Clarifications Dated 20-09-2019 to pre-bid queries on stipulations of Bid Documents

NIB No. 330 Dated 14-08-2019

Name of work : Rehabilitation of Penstock-II (Partly Underground and partly Over ground) of Kameng Hydro Electric Project (600 MW) located at Kimi, Arunachal Pradesh, India using a combination of Glass Fiber Reinforced Polymer (GFRP) and Carbon Fiber Reinforced Polymer (CFRP).

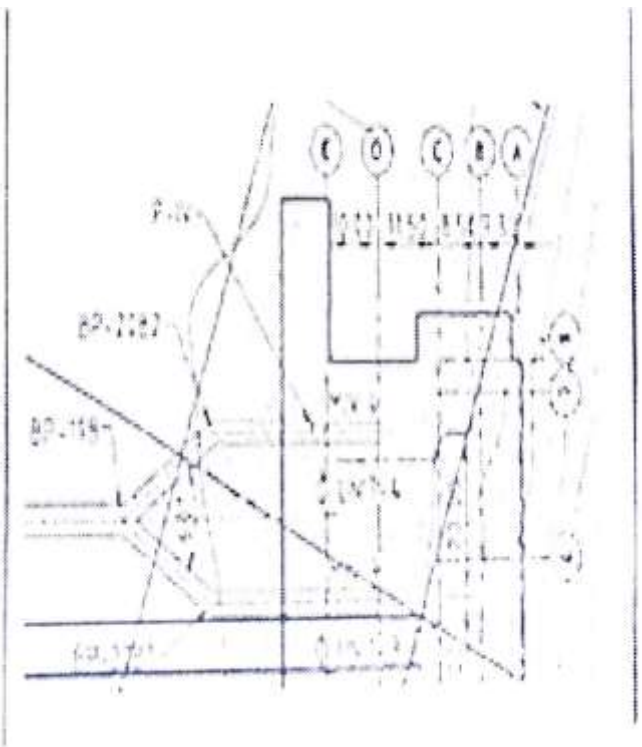
requisite value purchased by the Indian entity. Accordingly, the bidder shall submit along with their Techno-Commercial bid an undertaking to submit the said JDU on stamp paper at award stage.																																																											
6.	Part- 5 Technical Specifications	3	Design Methods and Requirements	Table 1 in Part- 5: technical Specification provide total 13 Zones of the Penstock (Zone 1A – Zone12). Please provide the thickness of the existing pipe section in each zone.	<p align="center"><u>Table-1: Zone Wise Thickness & Grade of Steel Liner</u></p>

<table border="1"> <tr> <td>P1-Z12 B1</td> <td>FACE 14</td> <td>2.65</td> <td></td> <td>32 & 40</td> </tr> <tr> <td>P1-Z12 B2</td> <td>FACE 15</td> <td>2.65</td> <td></td> <td>32 & 40</td> </tr> </table> <p>The aforesaid details are also incorporated in Drawing No. OMML/393/S-04, R-6 & OMML/393/S-05, R-5 (Copies enclosed).</p>	P1-Z12 B1	FACE 14	2.65		32 & 40	P1-Z12 B2	FACE 15	2.65		32 & 40
P1-Z12 B1	FACE 14	2.65		32 & 40											
P1-Z12 B2	FACE 15	2.65		32 & 40											
7.	-do-	3	Design Methods and Requirements	All material details of the existing penstock steel are missing in the tender. What is the Steel Grade, Steel Yield Strength and Modulus of Elasticity of the existing penstock steel in each zone.	Reply above may be referred. All the mechanical properties such as YP, UTS & Modulus of elasticity is to be taken as per steel grade indicated in the enclosed drawing. It may be clarified that the steel Grade SUMITEN-540 is equivalent to ASTM 517 CI-2 and SUMITEN-780 is equivalent to ASTM-517, Gr-F.										
8.	-do-	-do-	-do-	What is the Grade, Yield Strength and Modulus of Elasticity of the weld.	The mechanical properties of weld may be considered identical to steel material used in the respective section.										
9.	-do-	-do-	-do-	The thickness at the weld section to be taken as 1/4 th of the thickness of the original pipe thickness. Should the maximum stress at the weld section be limited to the weld yield stress after the provision of CFRP.	The thickness of Weld Section to be taken as % of the thickness of the original pipe thickness to simulate the cracks of weld. The maximum stress in weld is to considered same as allowed in the case of steel plate.										
10.	-do-	3.2g (Point-1)	Design Requirements	In this section, the bidder is required to provide FEM analysis of load transfer from MIV Inlet Pipe to CFRP Lining. Does this mean that the termination of FRP is at MIV 3 and MIV 4 and runs till Line D? or is the FRP needs to be wrapped on the concrete of MIV? What we understand from this is that an analysis is to check the bond stresses of CFRP. Is this the correct understanding? Please clarify. Could we get some detailed drawing of	Technical requirement for transfer of Hydraulic Thrust is clearly spelt out in the Bid document. Designer needs to carry out the detailed analysis and suggest adequate methodology for transfer of the Hydraulic Thrust as well as termination details of CFRP. The following Drawings pertaining to details of Penstock Pipe Beyond BP-19B are enclosed herewith:
